PLANNING AND ZONING COMMISSION REGULAR MEETING AGENDA

WEDNESDAY, AUGUST 9, 2017

CITY COUNCIL CHAMBERS, 105 E. EGGLESTON ST.

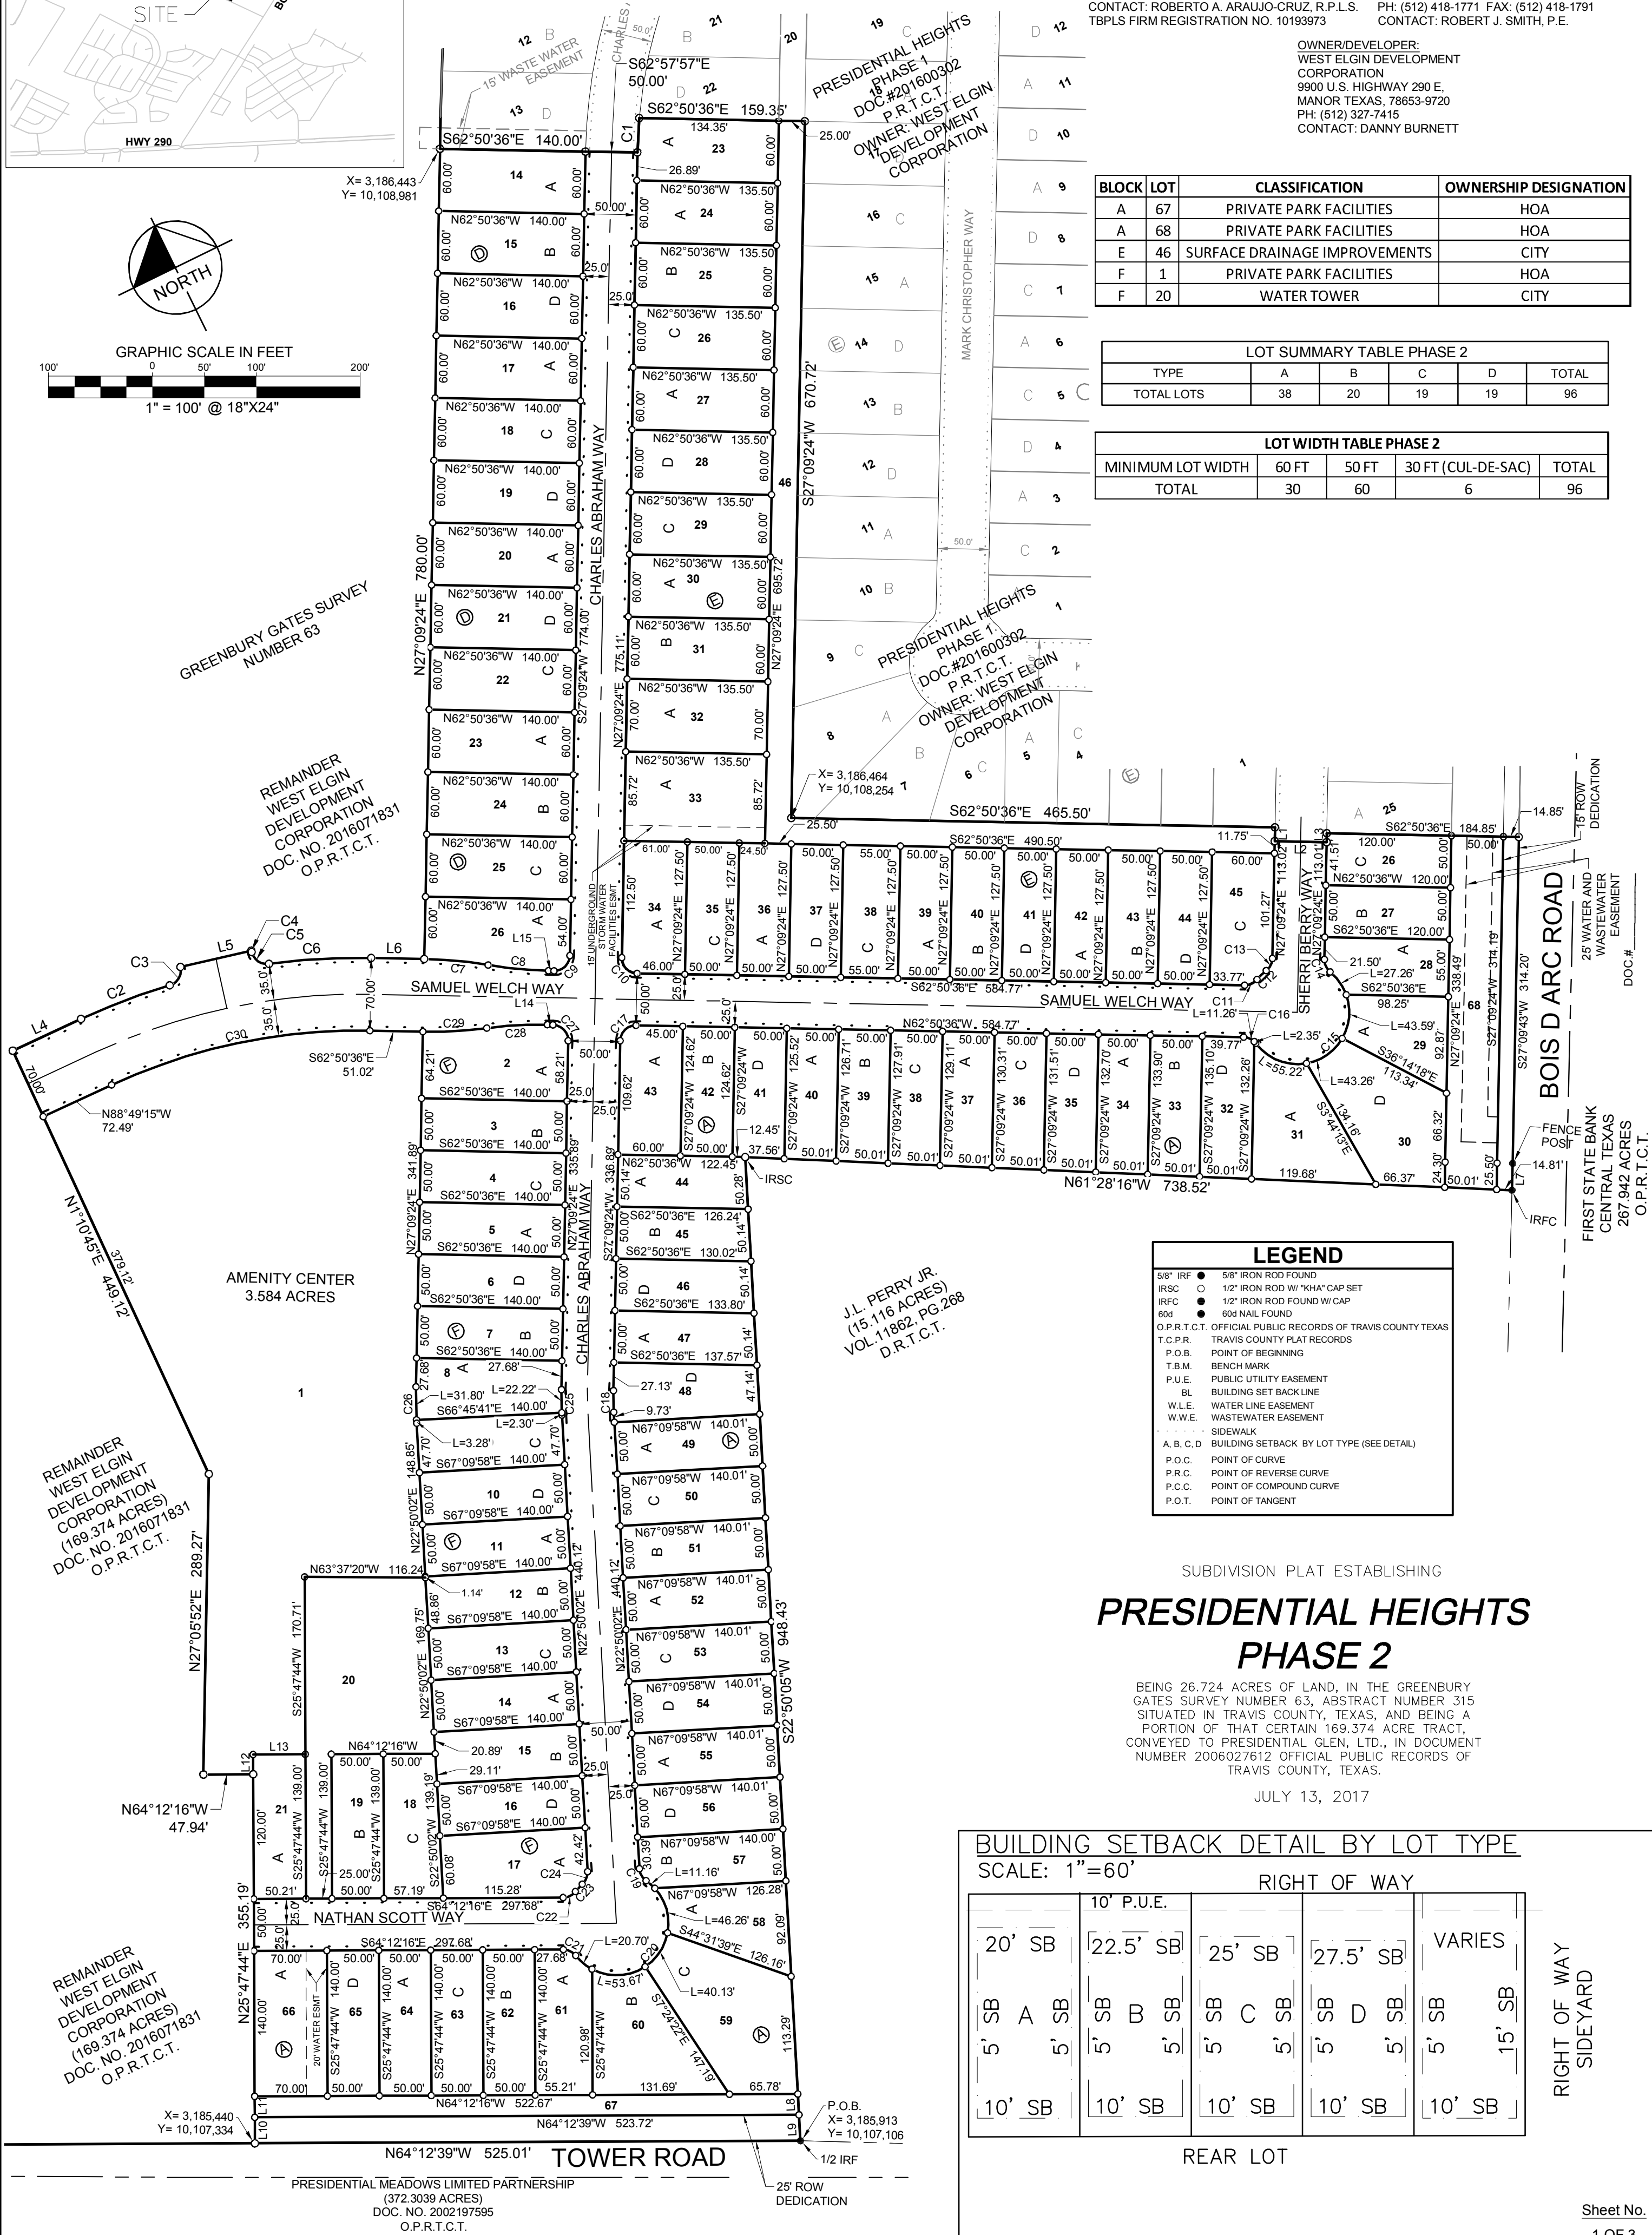
14. Lot 46 on Block E is to be maintained by the HOA. A note should be added to the plat stating this. See attached example note that was used in a previous section of Presidential Heights.

14. Lot 46 on Block E is to be maintained by the HOA. A note should be added to the plat stating this. See attached example note that was used in a previous section of Presidential Heights,

Response: Note has been added about maintenance responsibility of lot on sheet 2 of 3, note #5.

THE VILLAGE AT MANOR COMMONS PRELIMINARY PLAN NOT FOR RECORDATION

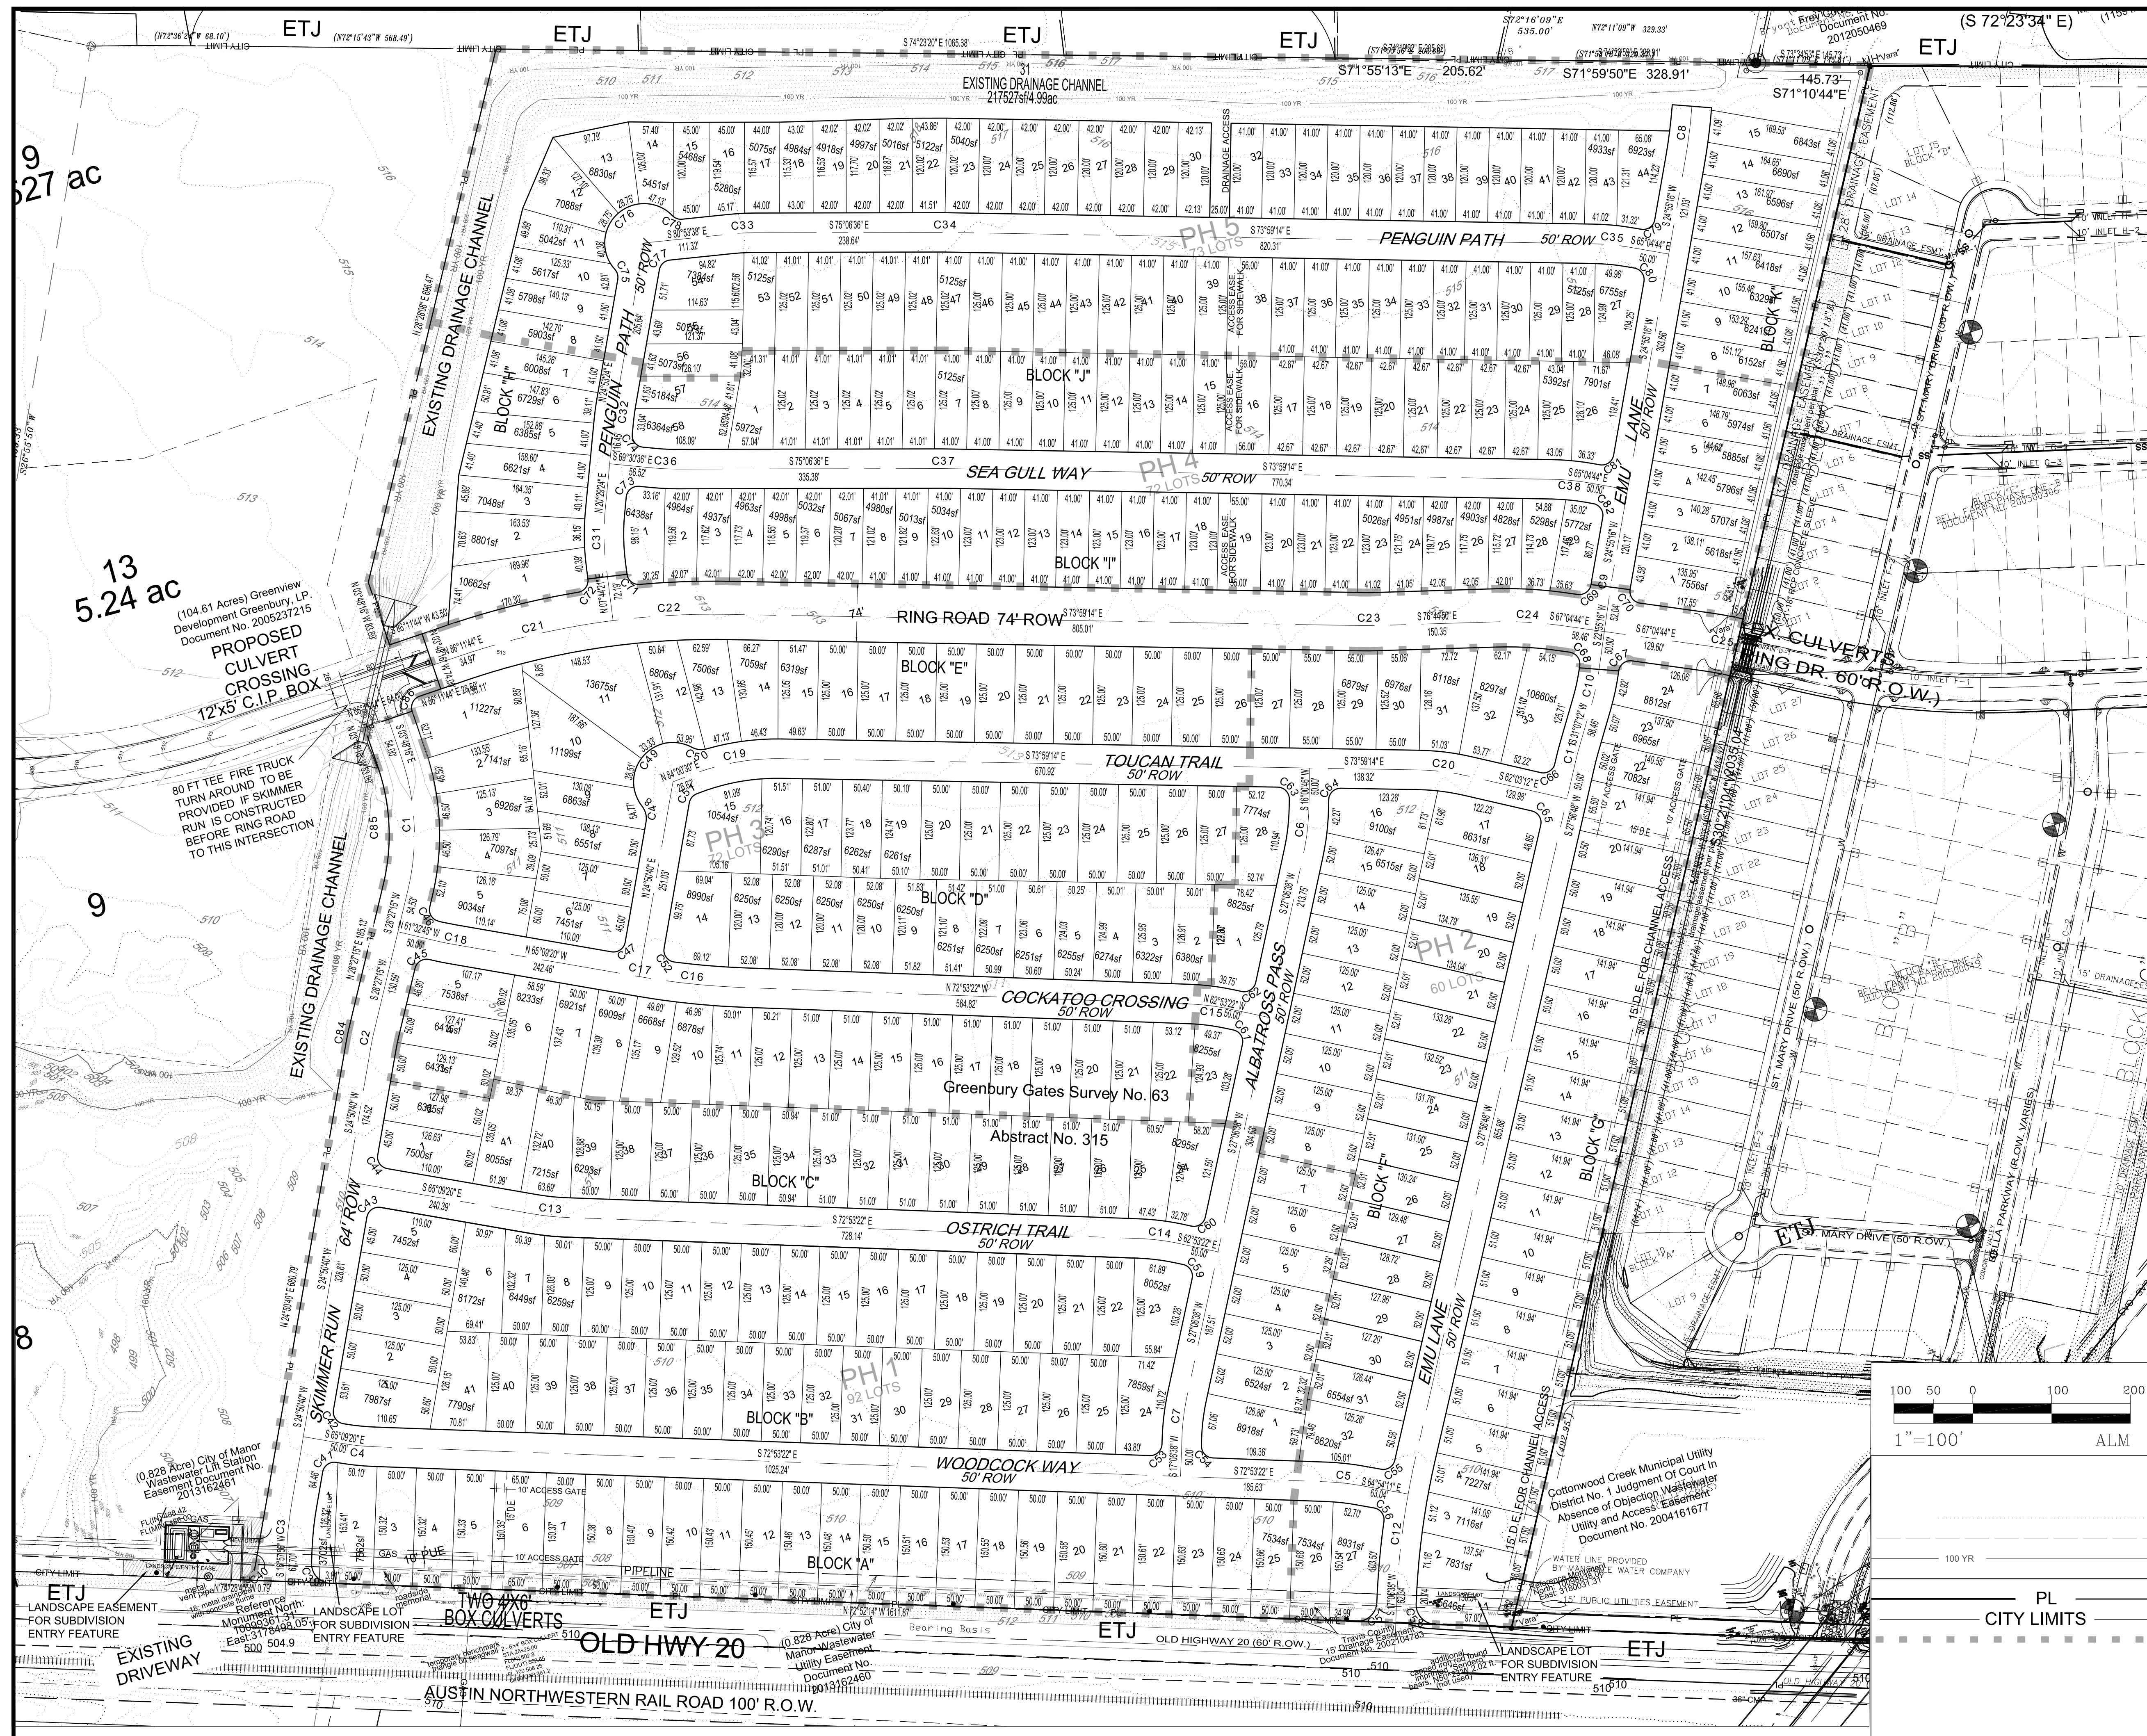
3. On Sheet 1 the linear footage of new streets is shown on the plan, but the only street listed is Ring Road.
4. There was no submittal date listed on Sheet 1.

3. On Sheet 1 the linear footage of new streets is shown on the plan, but the only street listed is Ring Road.

4. There was no submittal date listed on Sheet 1.

RESPONSE: Provided.
3. On Sheet 1 the linear footage of new streets is shown on the plan, but the only street listed is Ring Road.
RESPONSE: Added.
4. There was no submittal date listed on Sheet 1.

RESPONSE: Added.
5. Due to the scale of the drawing, the different linetypes are hard to distinguish from one another. Per Section 22(b) of Subdivision Ordinance 263B the scale of the drawings should be 1" = 100'.
